I disagree with the merit assessment to allow the non-compliant second parking space for each subdivided lot to be within the 6.5m front setback of the property.

Peter Robertson – 13 Greenwood Ave, Narraweena.

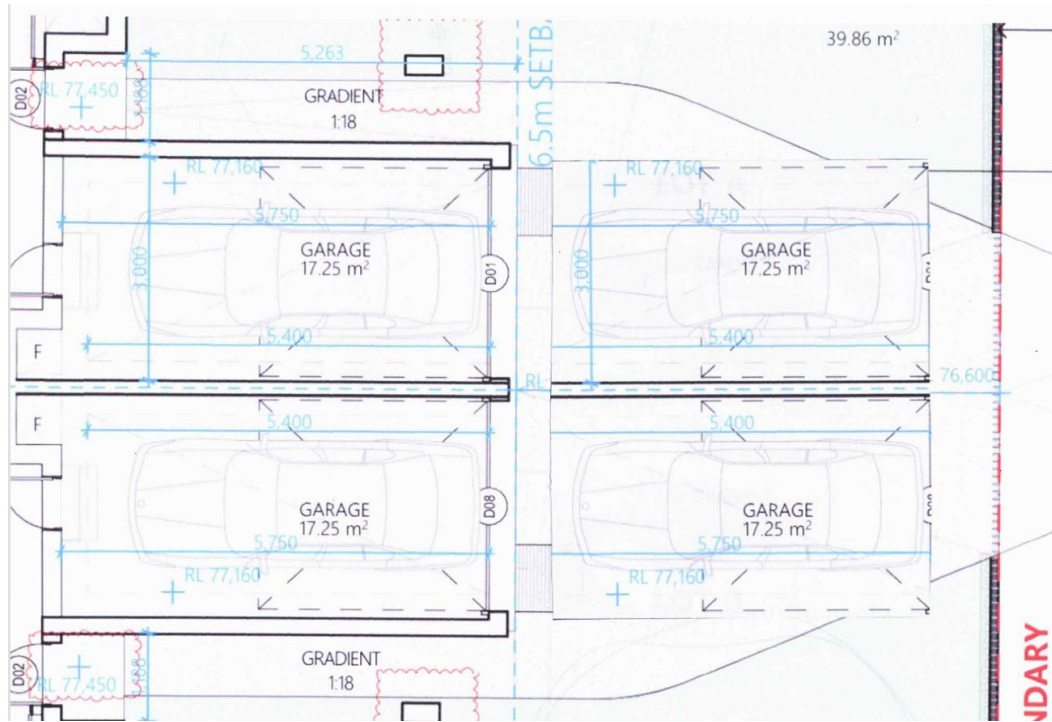
These two proposed parking spaces do not allow sufficient space for safe entry/exit of the shared driveway. The icons used (of cars in the garage) within the plans are sneakily small, and do not represent the true nature of parking two cars within this small area whilst safely driving in and out of the driveway. I was informed by The Northern Beaches Council that engineers had inspected this situation and approved the safe entry/exit of the shared driveway and the ability of each car to actually turn into and park in these non-compliant spaces. Could Northern Beaches Council please provide evidence of the engineers investigations into how these cars could manoeuvre into their desired car space, from the shared

driveway. I have cut and pasted the car icons onto the plans to show the nature of what is trying to be achieved. Each lot will have approximately 1 meter from the boundary to attempt to turn into or out of these car spaces from the shared driveway. It would be extremely crowded and near impossible for a standard size car.
